# STATE OF OHIO DEPARTMENT OF TRANSPORTATION

## DEF-24-11.35

CONSTRUCT A NEW 0.42 MILE 2-LANE OVERPASS AT THE US24/CR 185 AT-GRADE INTERSECTION & REMOVE CURRENT INTERSECTION. THE PROJECT CONSISTS OF RAISING CR 185 OVER US24 ON THE EXISTING ALIGNMENT, CONSTRUCTING A NEW 2-SPAN BRIDGE & REMOVING INTERSECTION PAVEMENT ON US 24 & RESTORING US 24 TO A 4-LANE DIVIDED FACILITY.

ADDENDUM	NUMBER	DATE	DESCRIPTION
	1	02/14/2025	UPDATED DATE

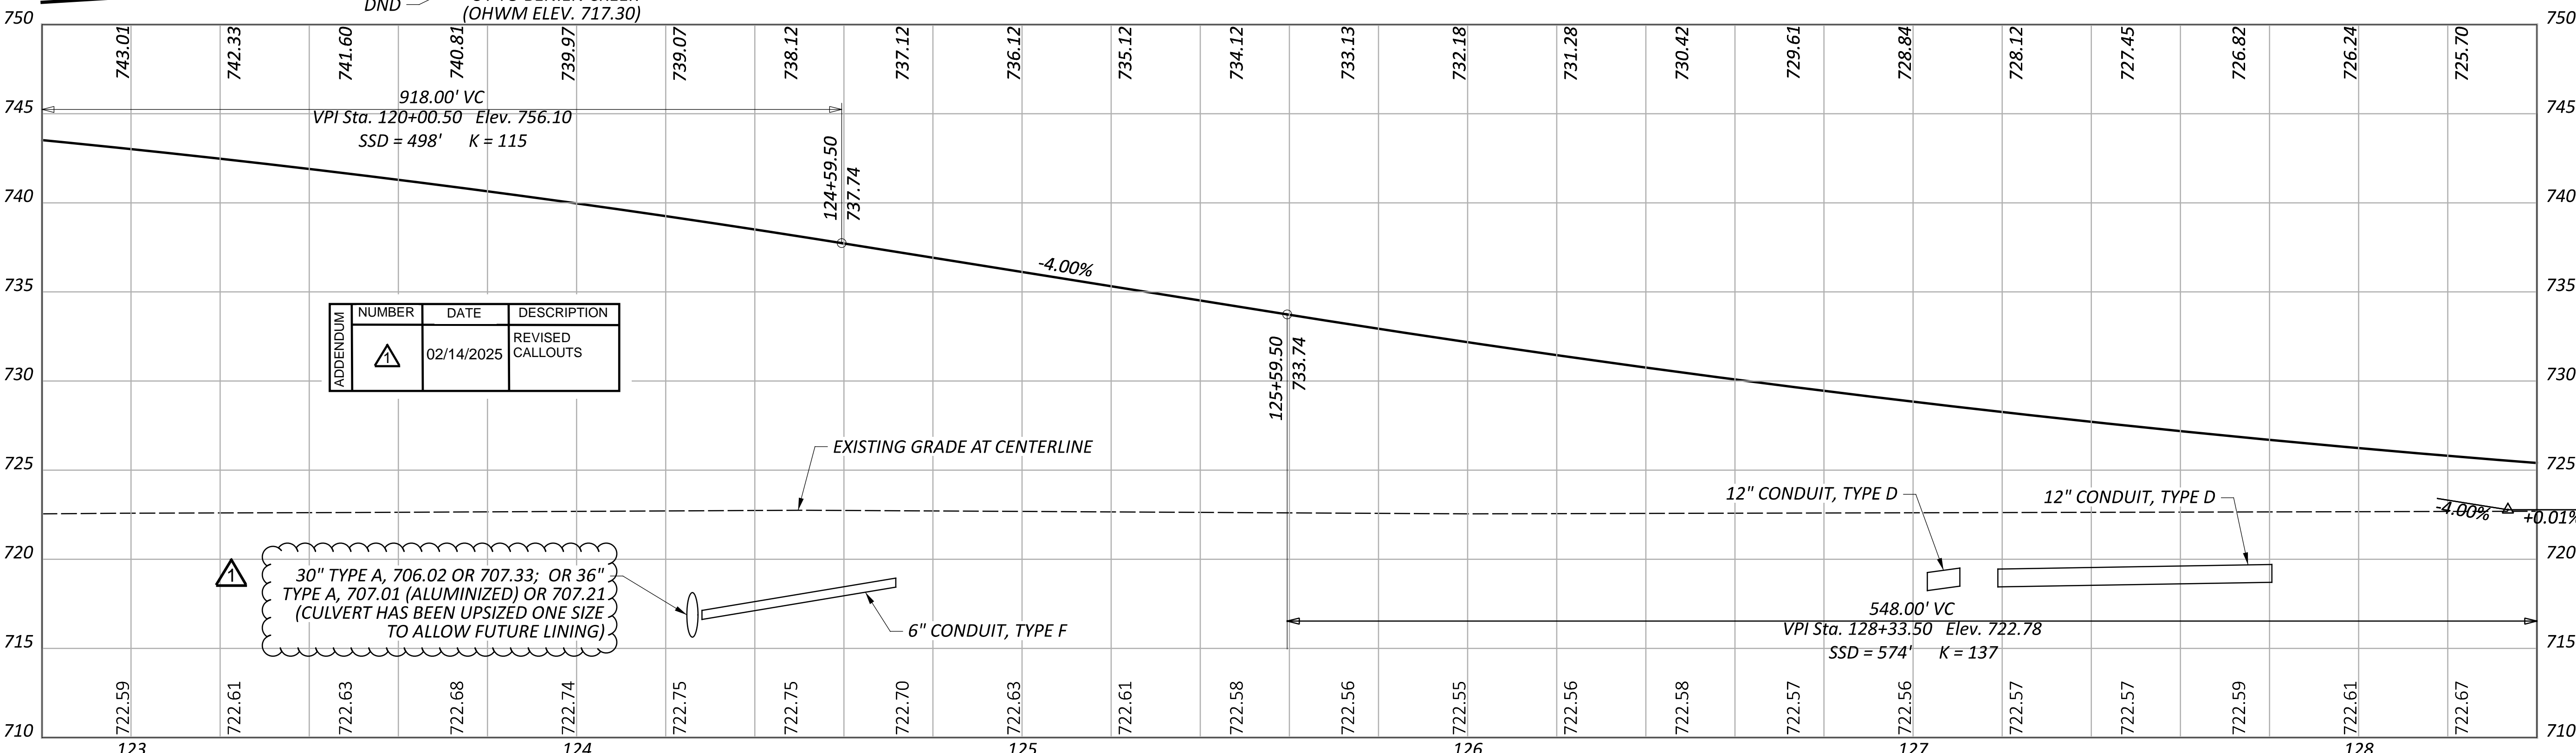
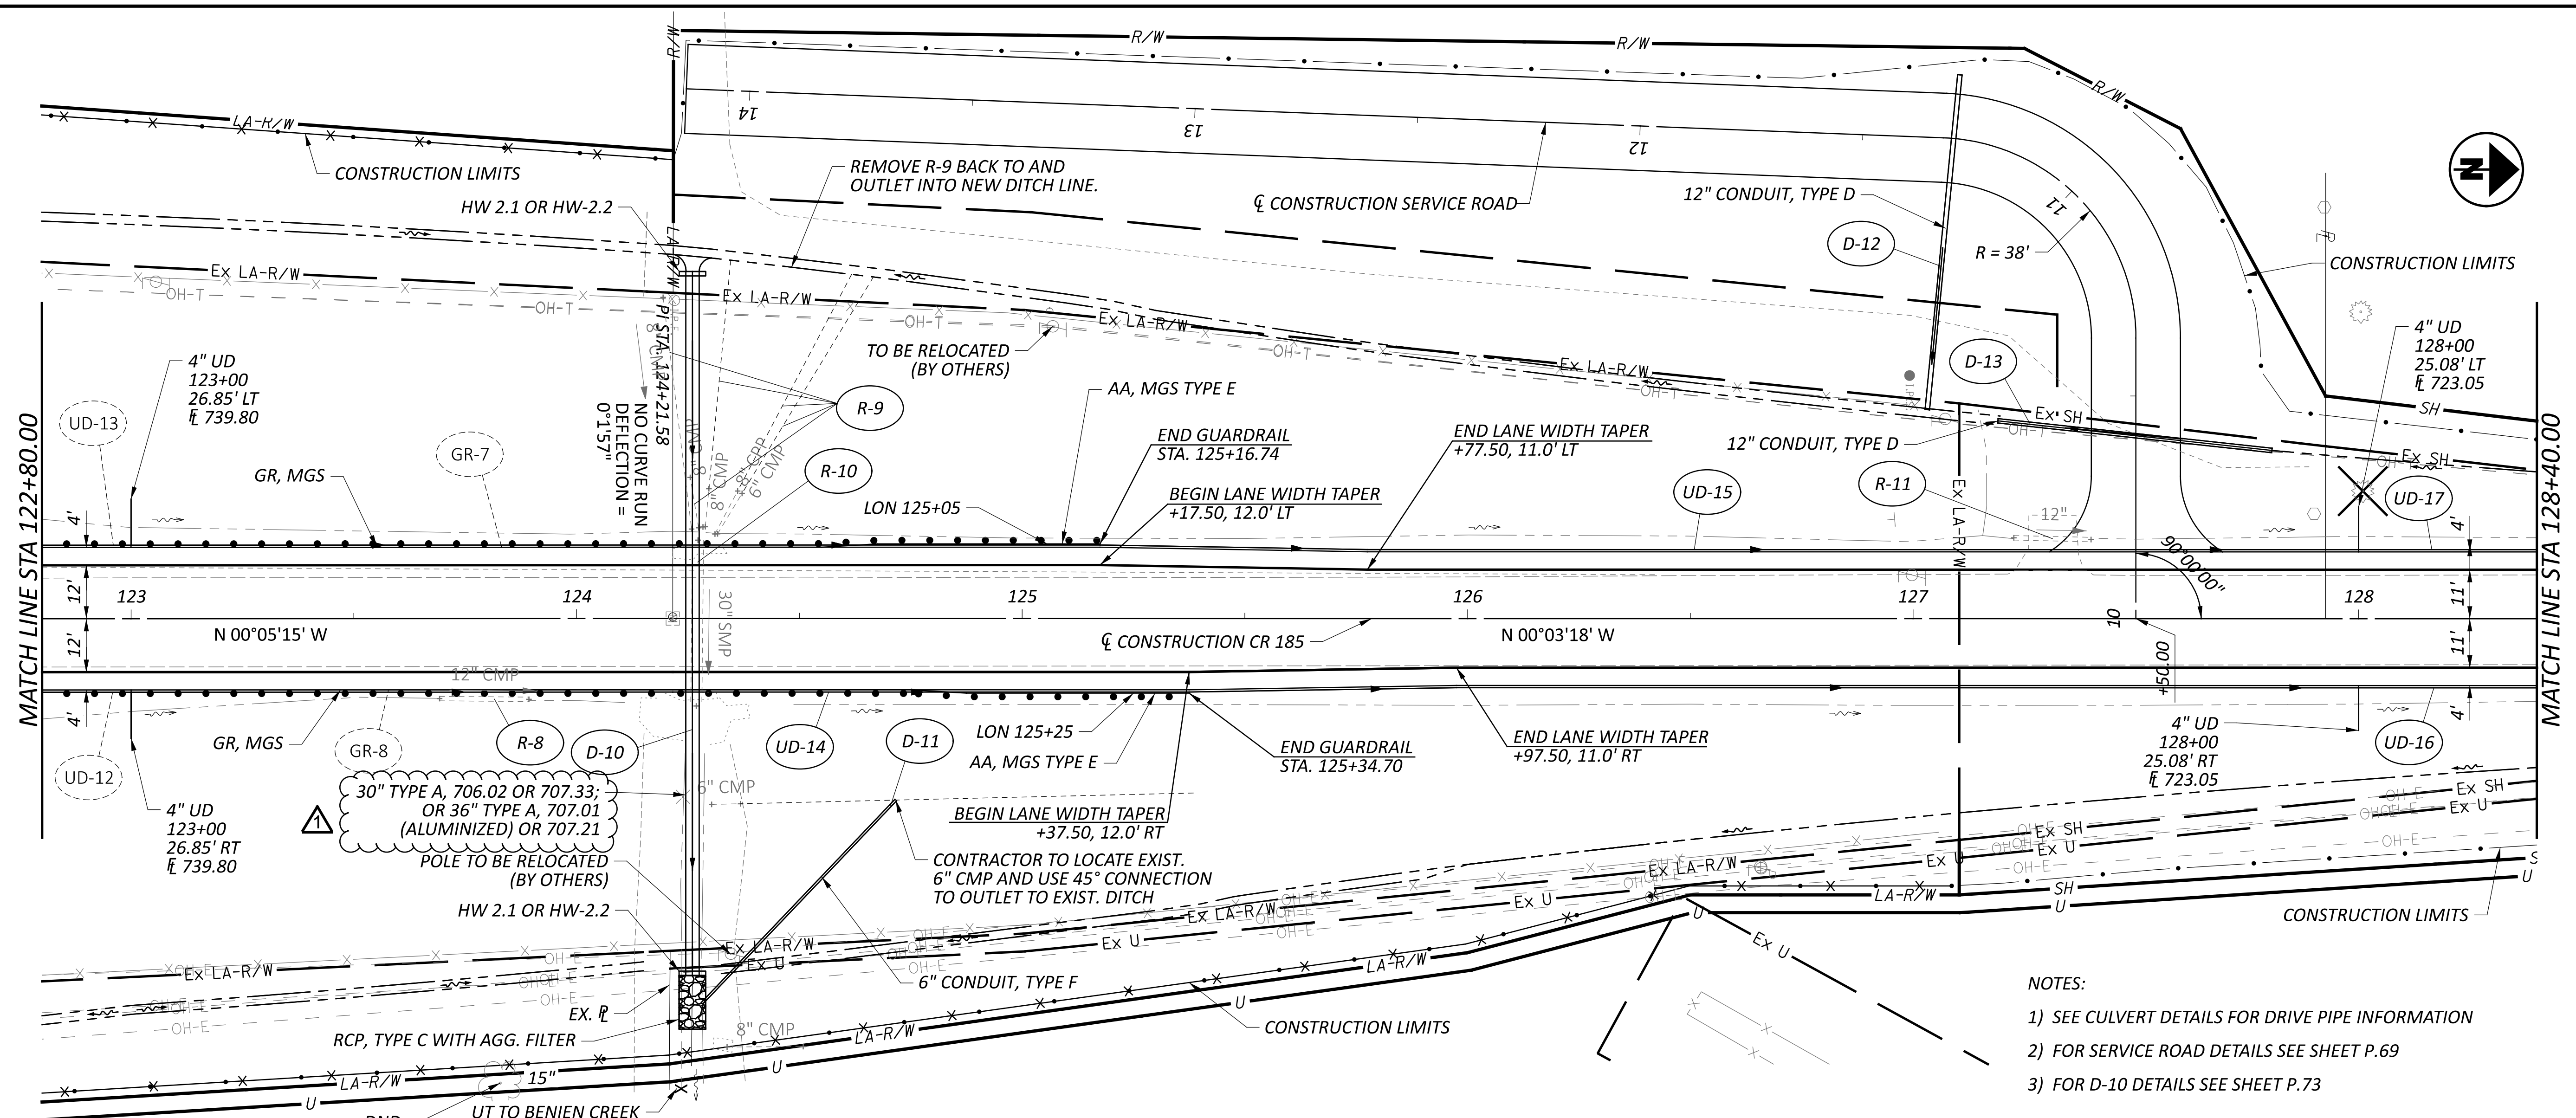
APPENDIX	NUMBER	DATE	DESCRIPTION
▲	▲	02/14/2025	REVISED CALLOUTS

▲ 30" TYPE A, 706.02 OR 707.33; OR 36" TYPE A, 707.01 (ALUMINIZED) OR 707.21 (CULVERT HAS BEEN UPSIZED ONE SIZE TO ALLOW FUTURE LINING)

CROSS SECTIONS - C.R. 185  
 STA. 118+00 TO STA. 118+21.62

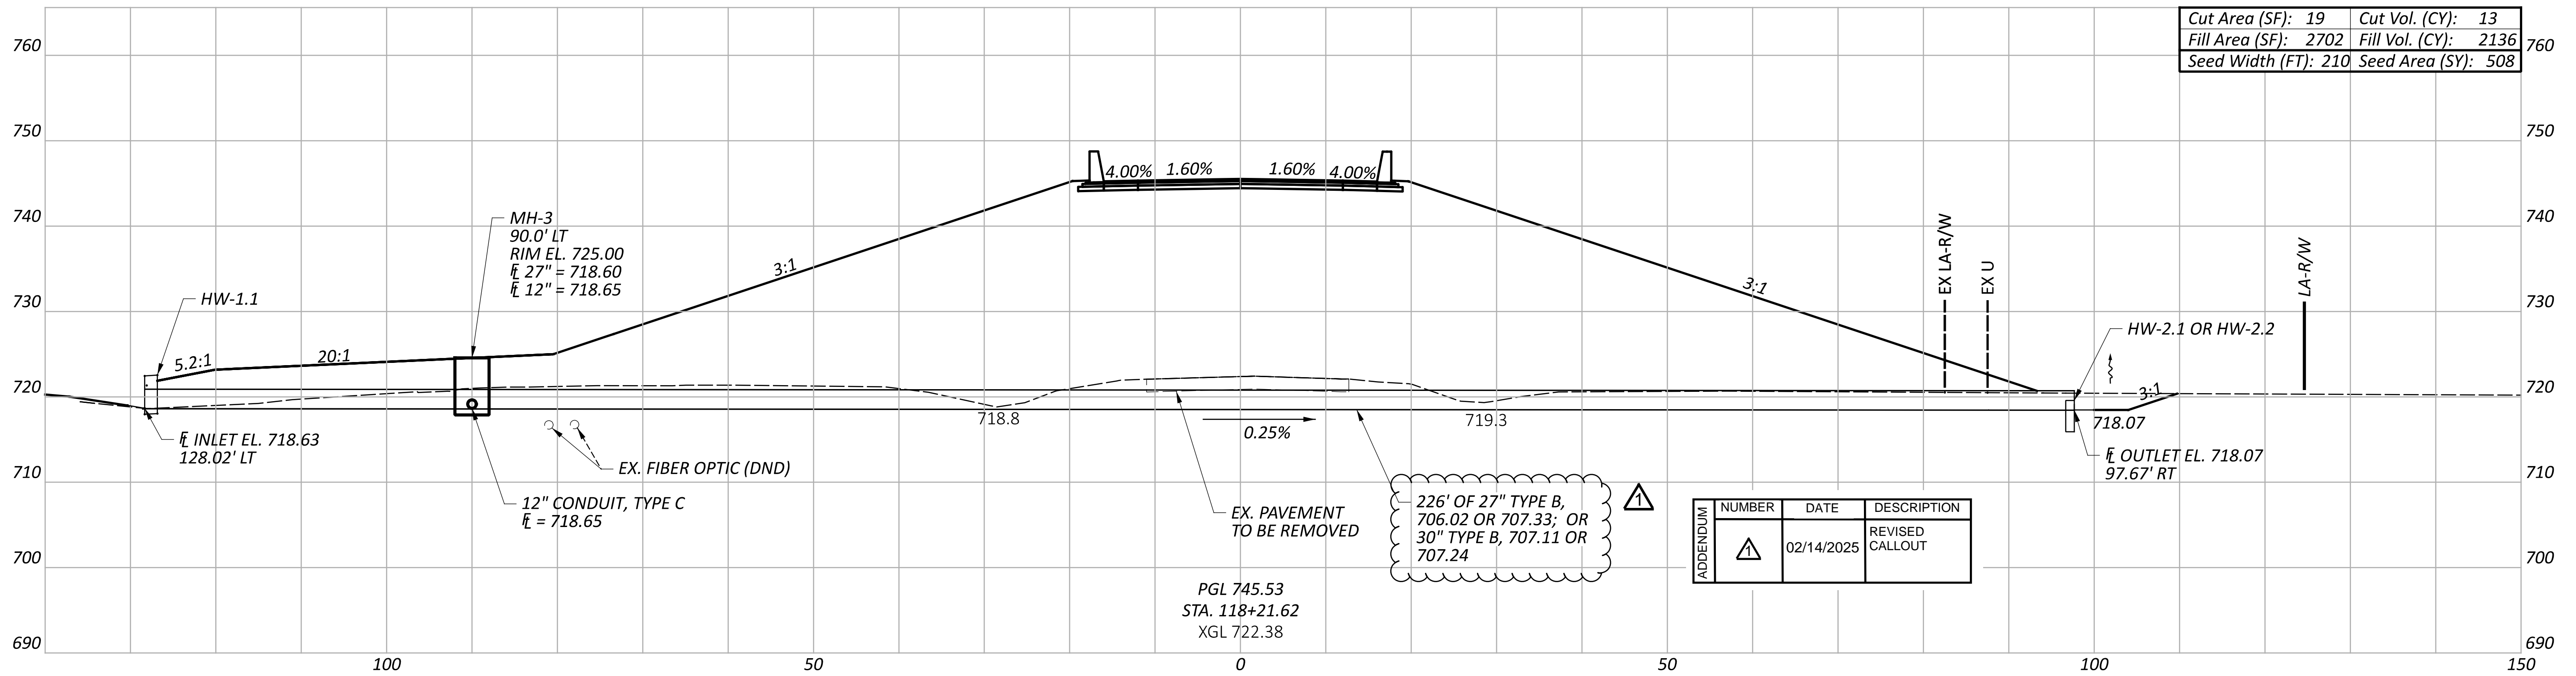
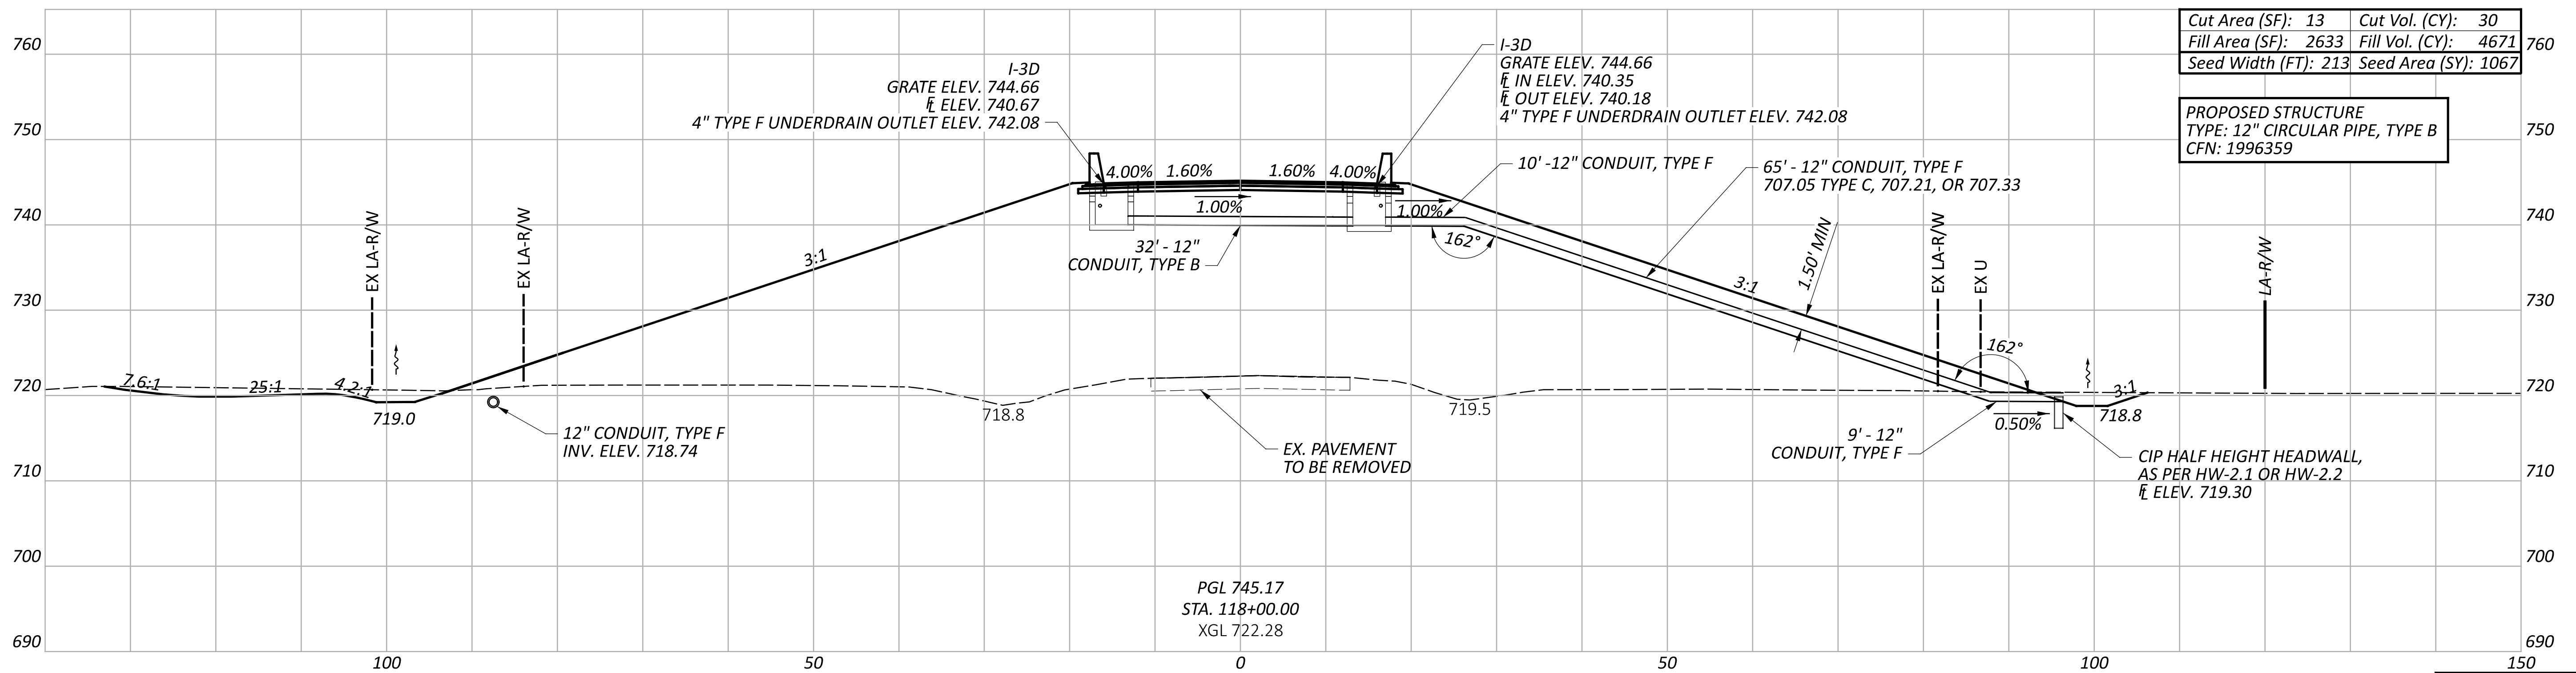
APPENDIX	NUMBER	DATE	DESCRIPTION
▲		02/14/2025	REVISED CALLOUT

PROPOSED STRUCTURE  
 TYPE: 12" CIRCULAR PIPE, TYPE B  
 CFN: 1996359
